ADDENDUM NO. 2

GS# 203-053 East Central Community College Band Hall Addition Decatur, MS.

EAST CENTRAL COMMUNITY COLLEGE
NEW BAND HALL
DECATUR, MISSISSIPPI

GS # 203-056
 EAST CENTRAL
 COMMUNITY COLLEGE
 BAND HALL ADDITION
 DECATUR, MS.

SHEET NO.
 SA-1

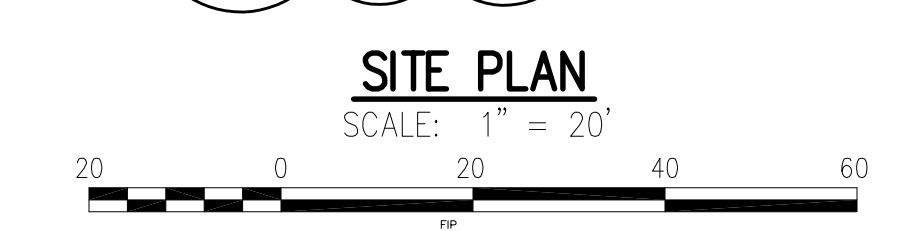
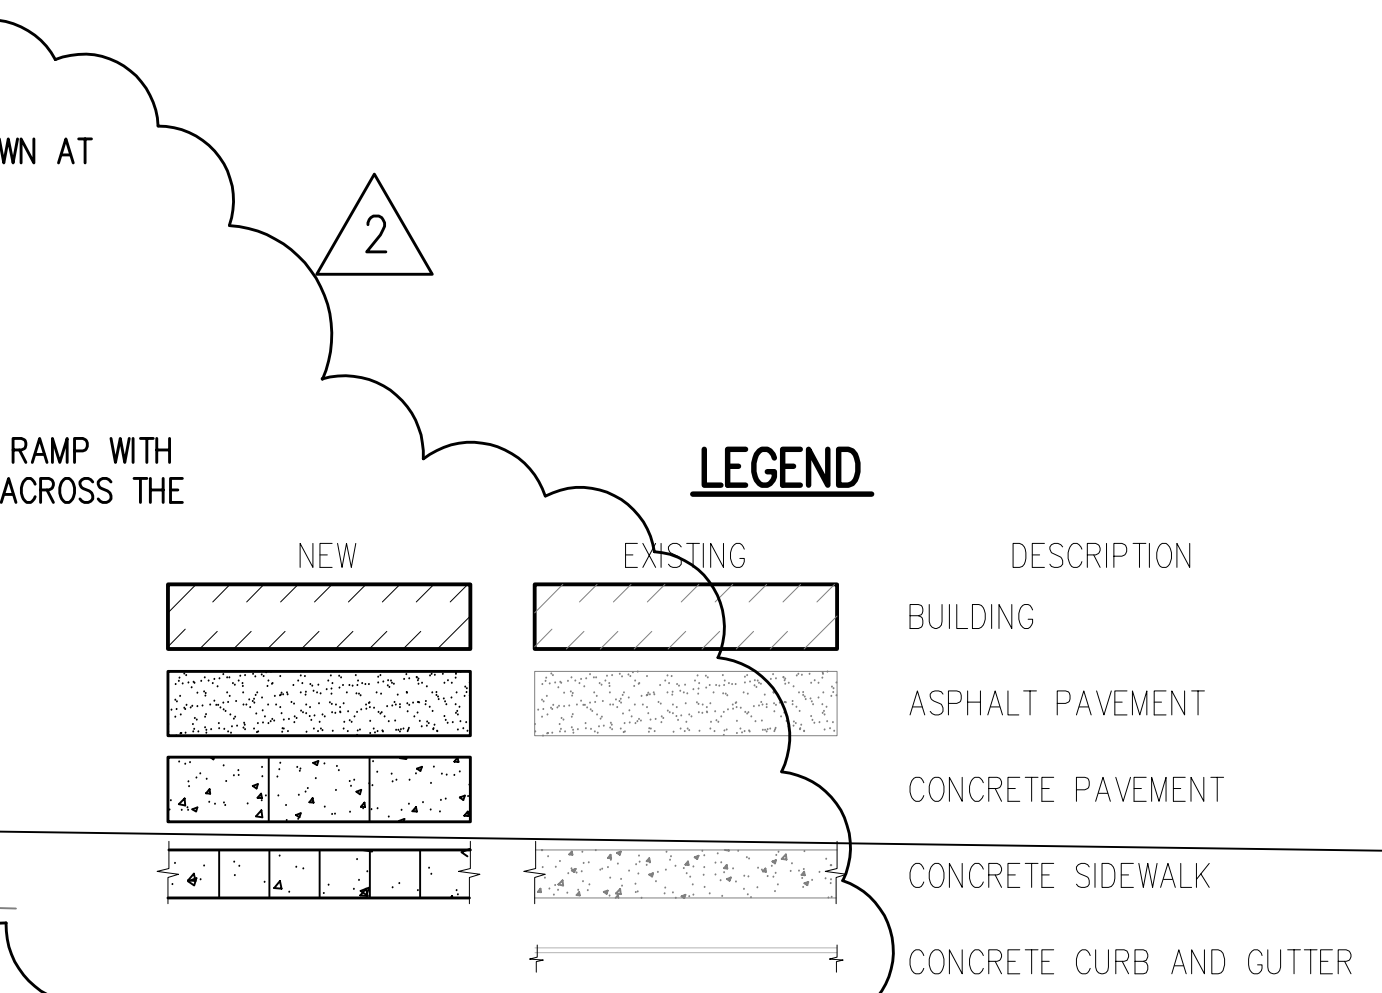
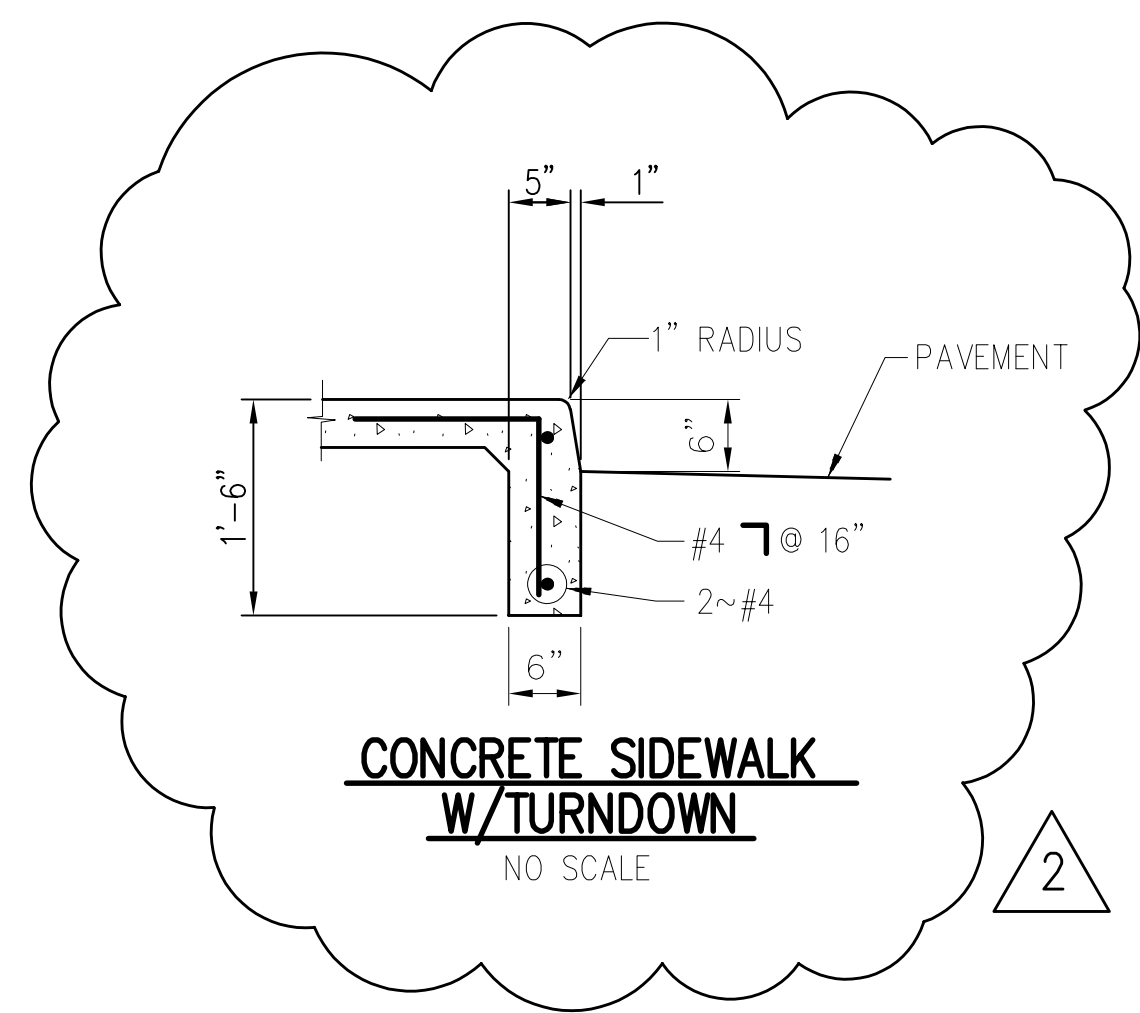
- B. Detail 1 – Note the footing reinforcing to be #6 @ 10” O.C., E.W., Top and bottom. Trench Drain notation shall be to “see C5.0”. See attached sketch SA-1.

PROJECT NO. 18-4840	SHEET NO. C2.0
DRAWN BY KSM	CHECKED BY

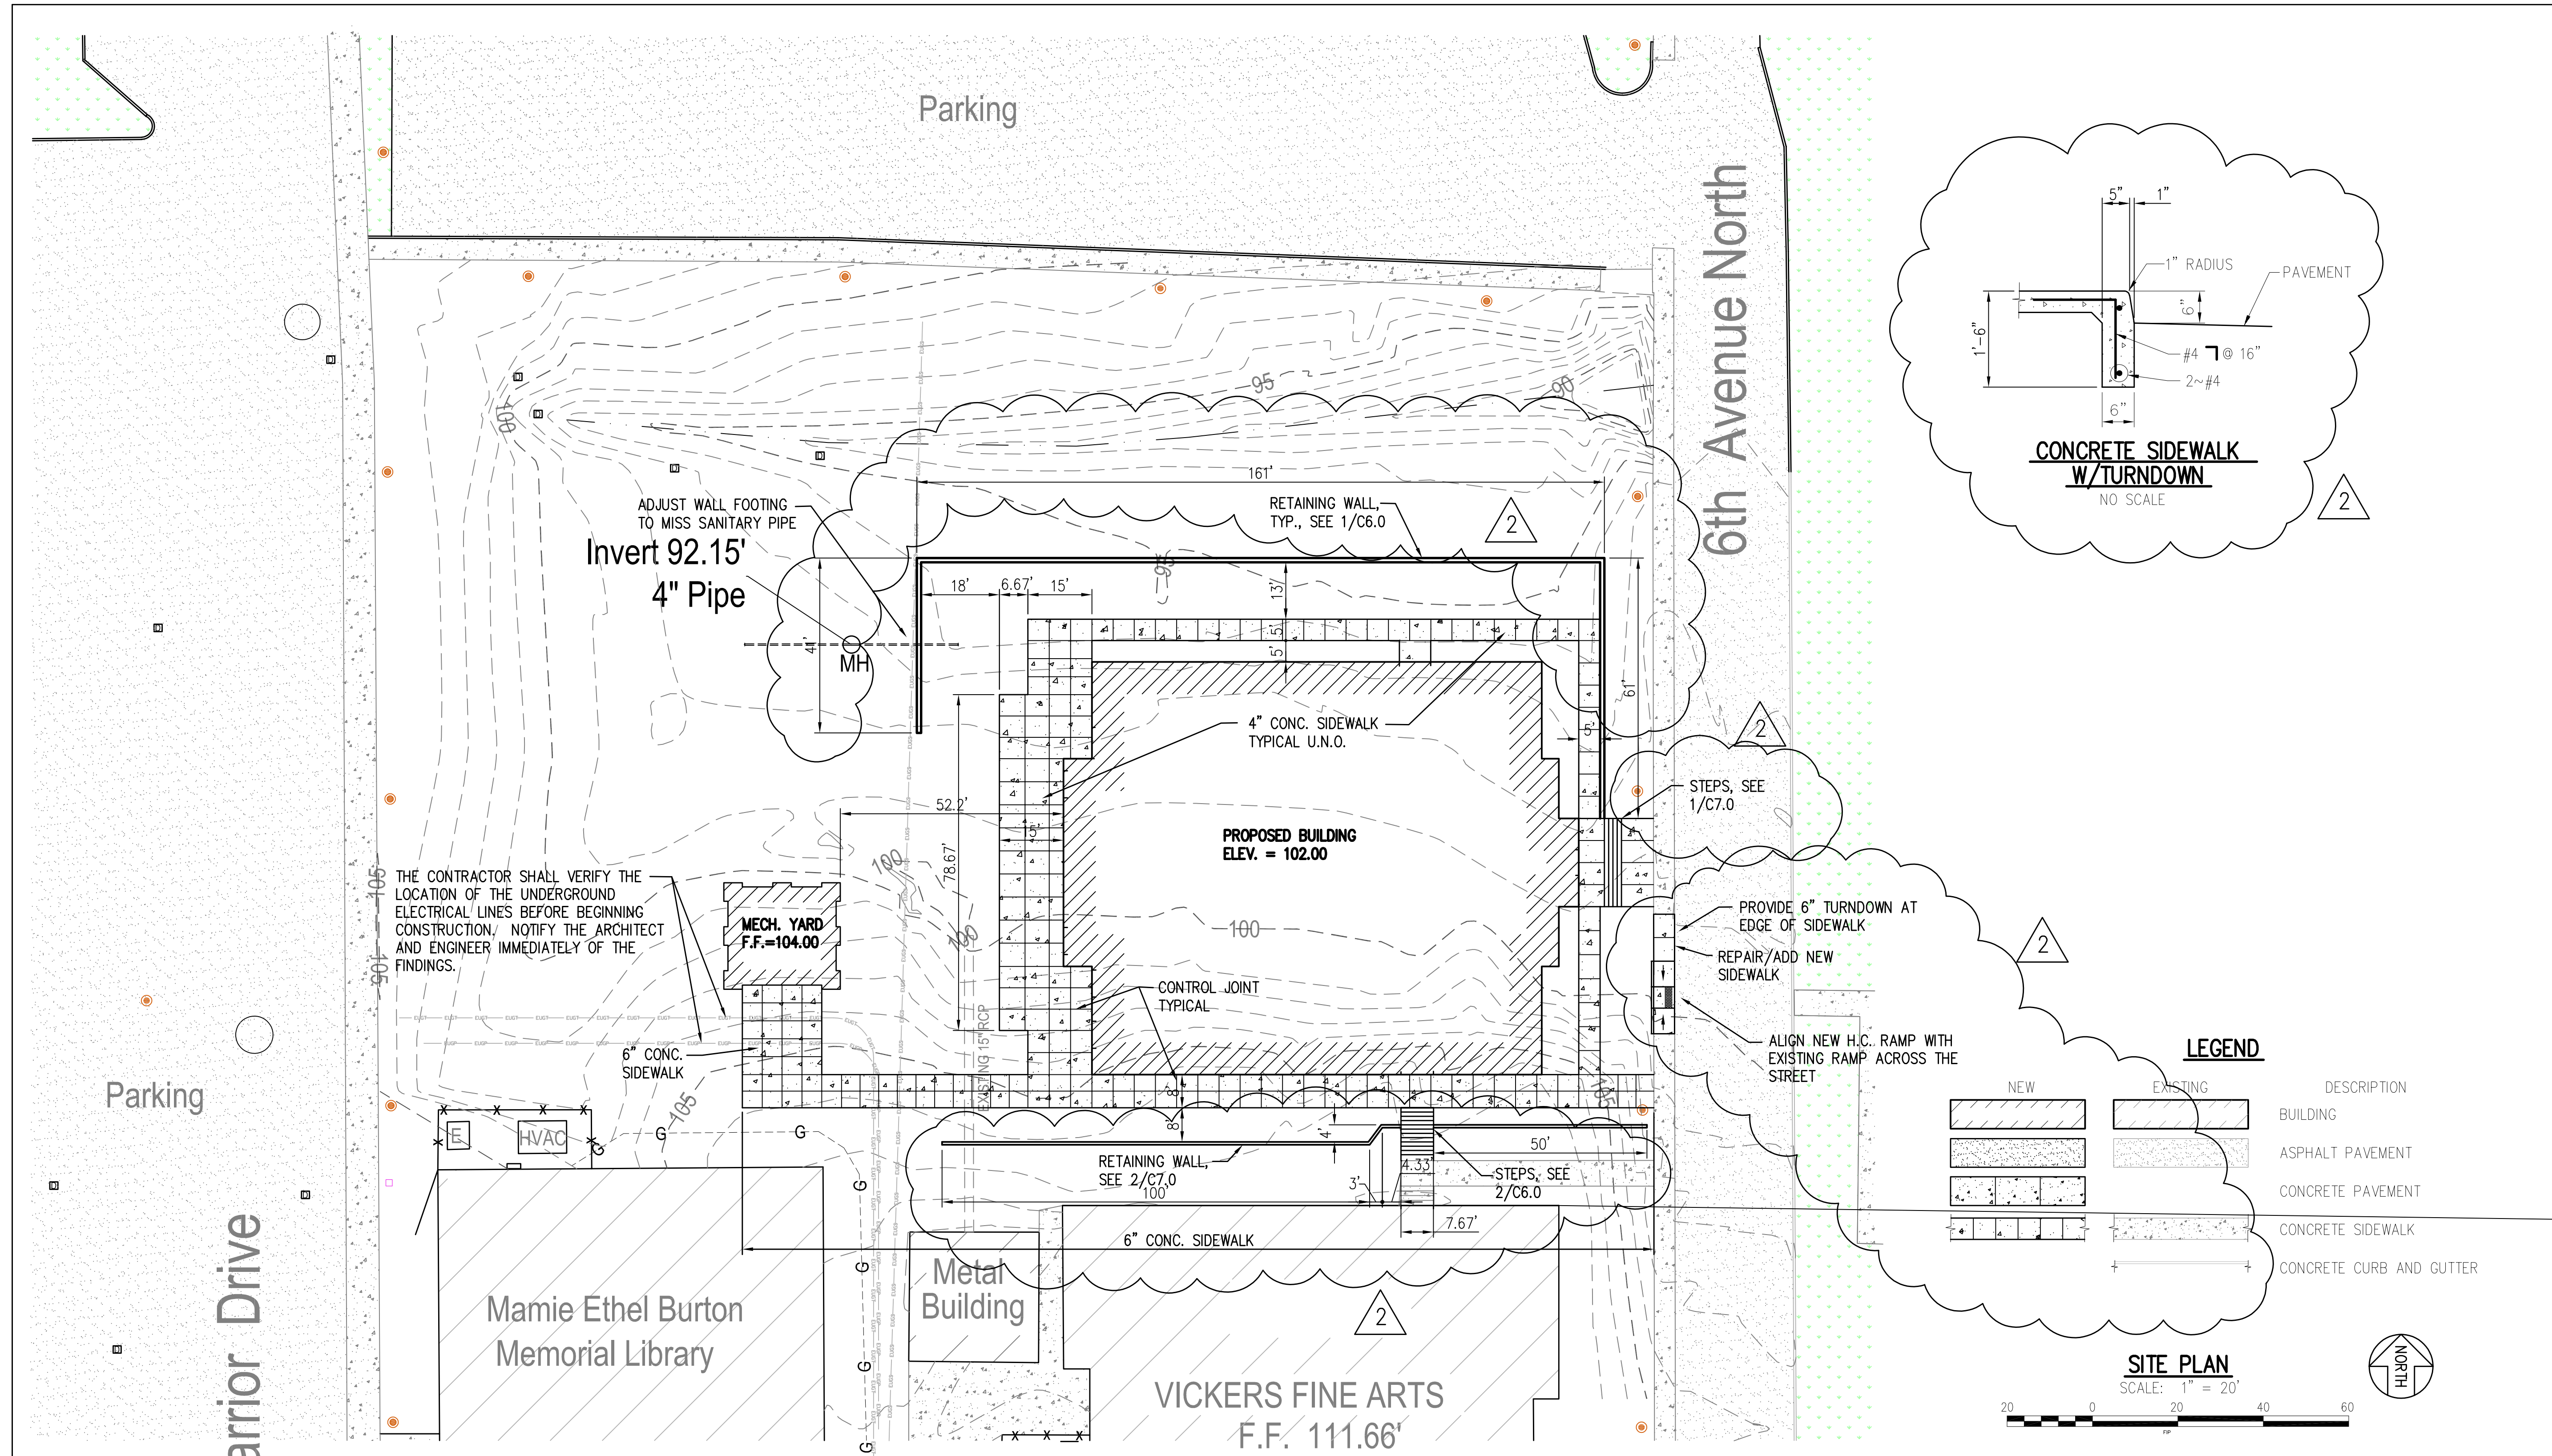
- Item No. 1 Ref. Sheet C2.0 –
- A. Re-label notations for details 1/C-501, 2/C-501, 1/C-502, and 2/C-502 to be 1/C6.0, 2/C6.0, 1/C7.0, and 2/C7.0 respectively. See attached sheet C2.0.

- B. In the Legend, omit New Curb and Gutter notation. Add note at sidewalk repair: “Provide 6” Turndown at edge of sidewalk.” See attached sheet C2.0.

- C. Add dimensions to the retaining walls. See attached sheet C2.0.
 - D. Add detail “Concrete Sidewalk W/ Turndown. See attached sheet C2.0
- Item No. 2 Ref. Sheet C4.0 –

PROJECT NO. 18-4840	SHEET NO. C4.0
DRAWN BY KSM	
CHECKED BY

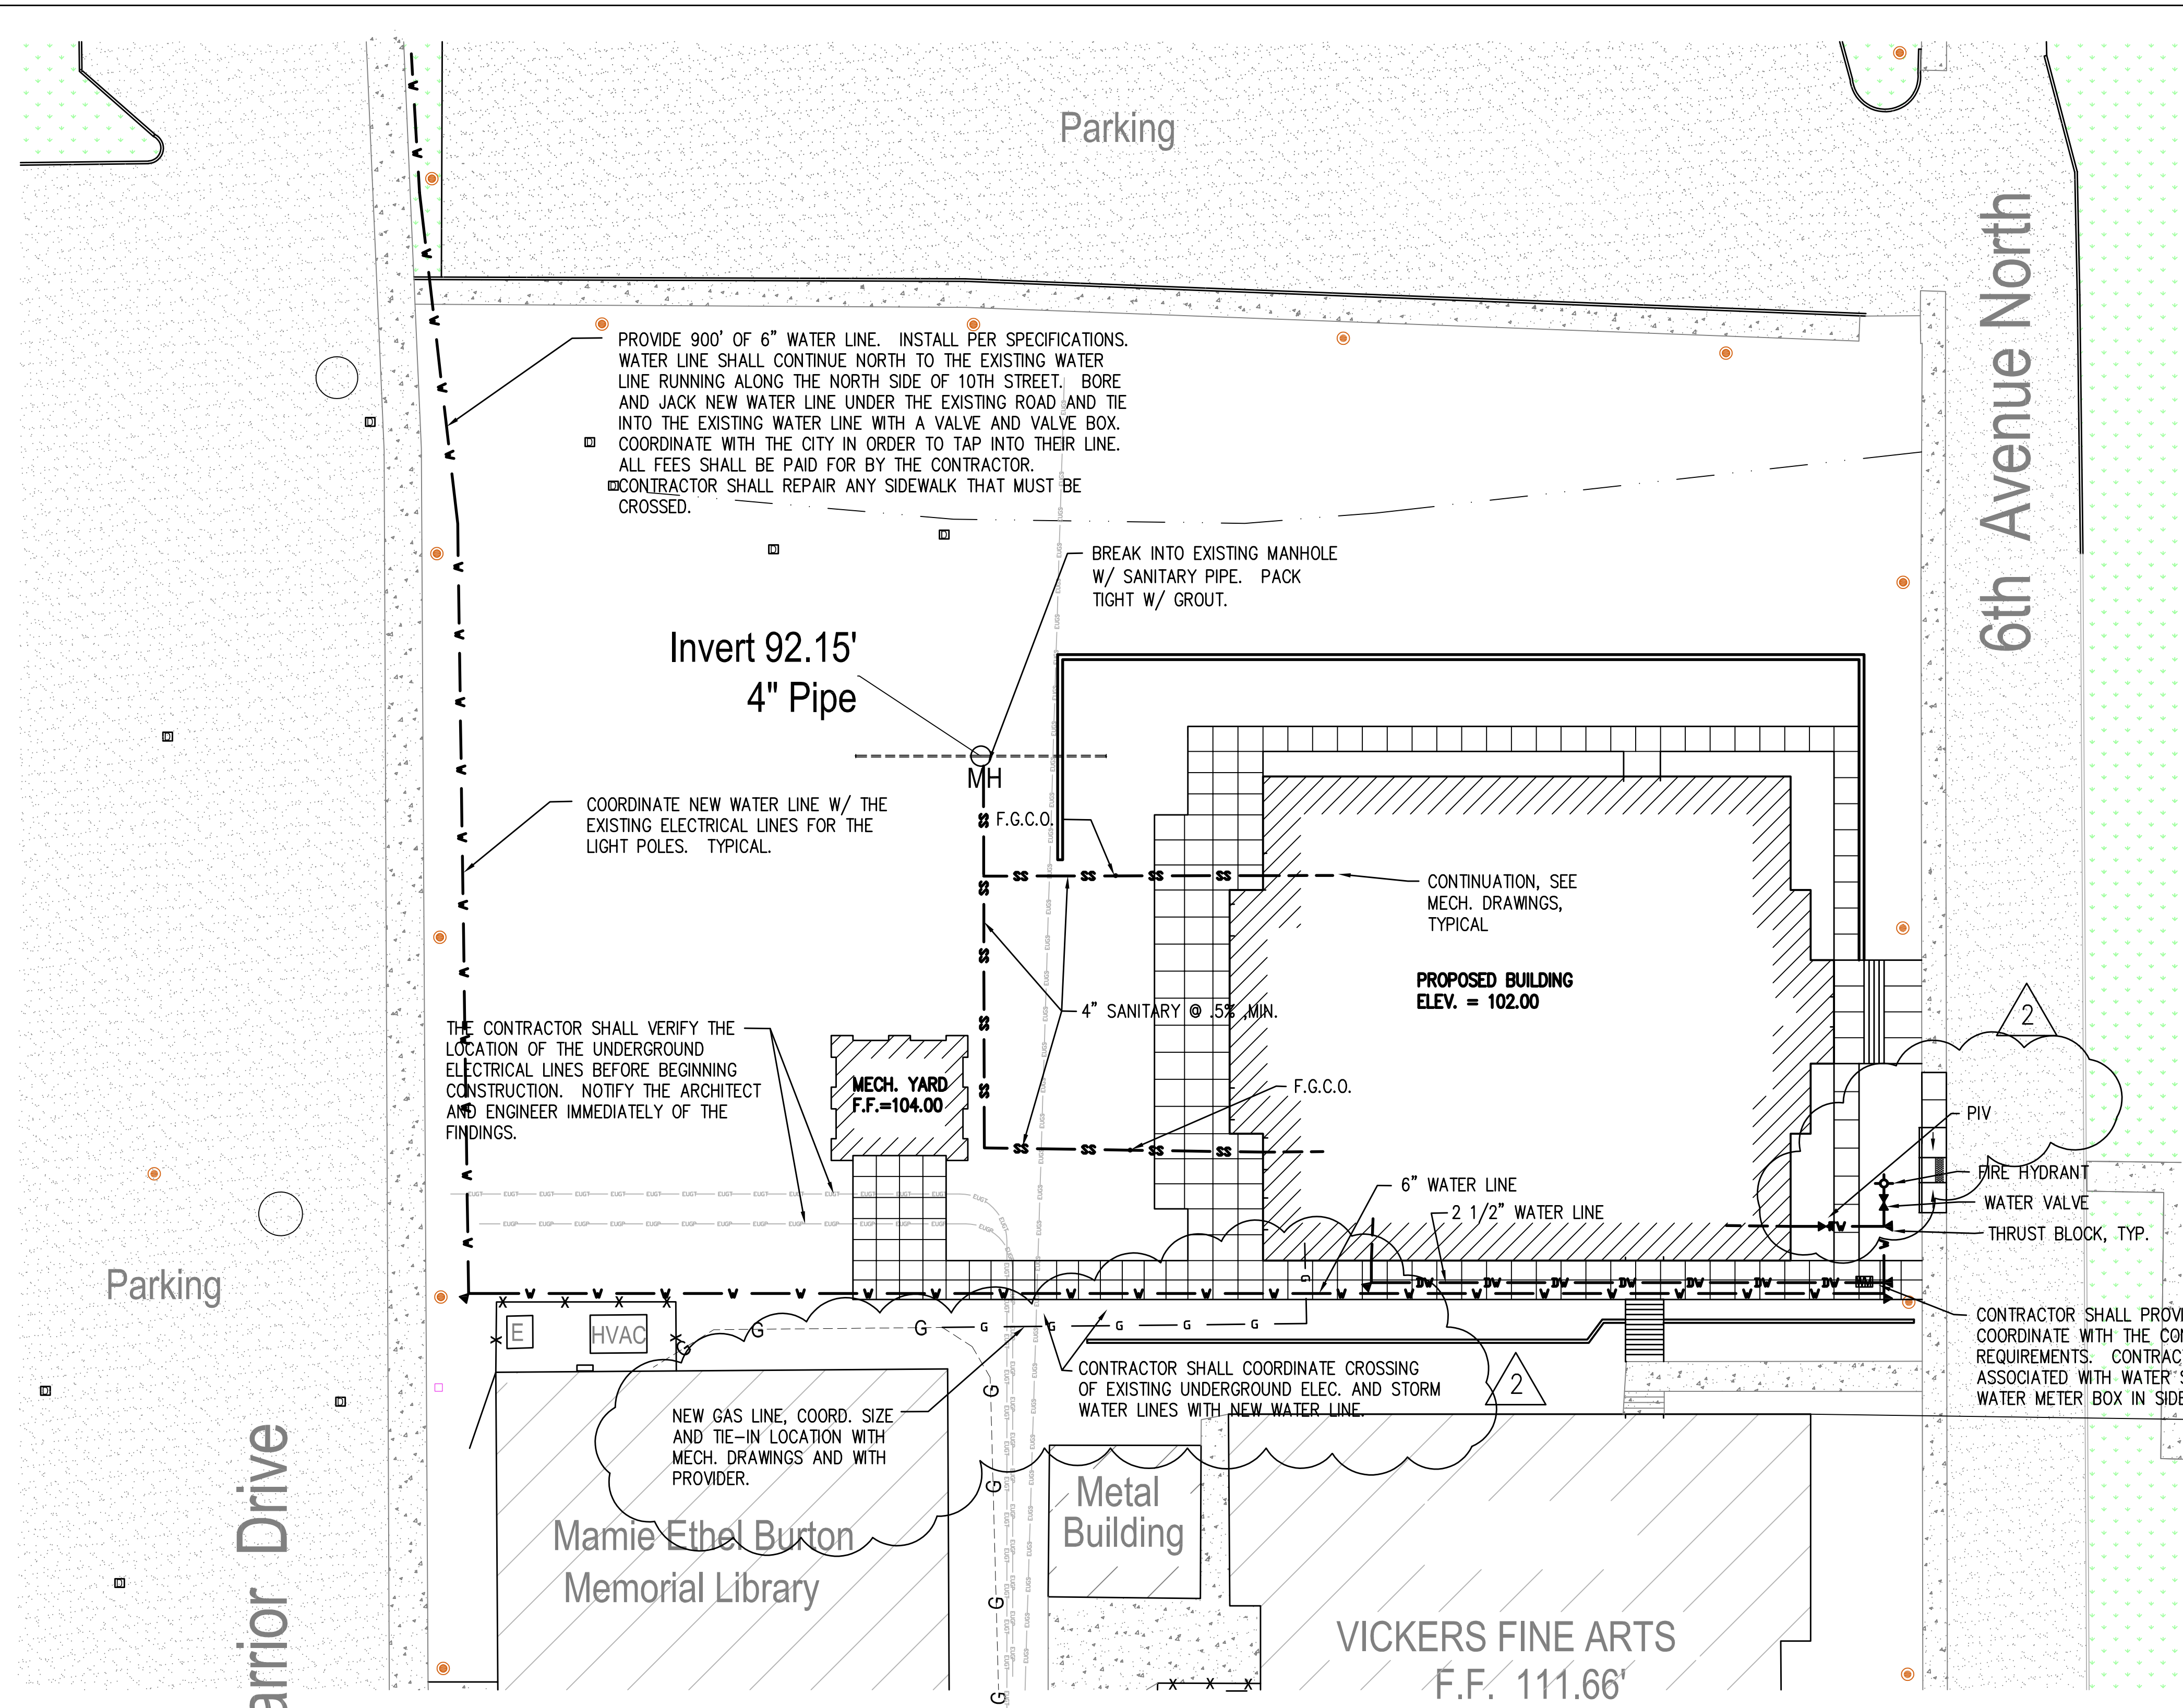
- A. Omit Fire Department Connection stand-pipe. See attached sheet C4.0
 - B. Add new Gas Line. See attached sheet C4.0.
- Item No. 3 Ref. Sheet C6.0 –
- A. “Typical Exterior Edge of 6” Sidewalk Detail” and “ 6” Concrete Sidewalk Joint Details”, all slabs noted in these details shall be 6” thick.

NEW GAS LINE, COORD. SIZE
AND TIE-IN LOCATION WITH
MECH. DRAWINGS AND WITH
PROVIDER.
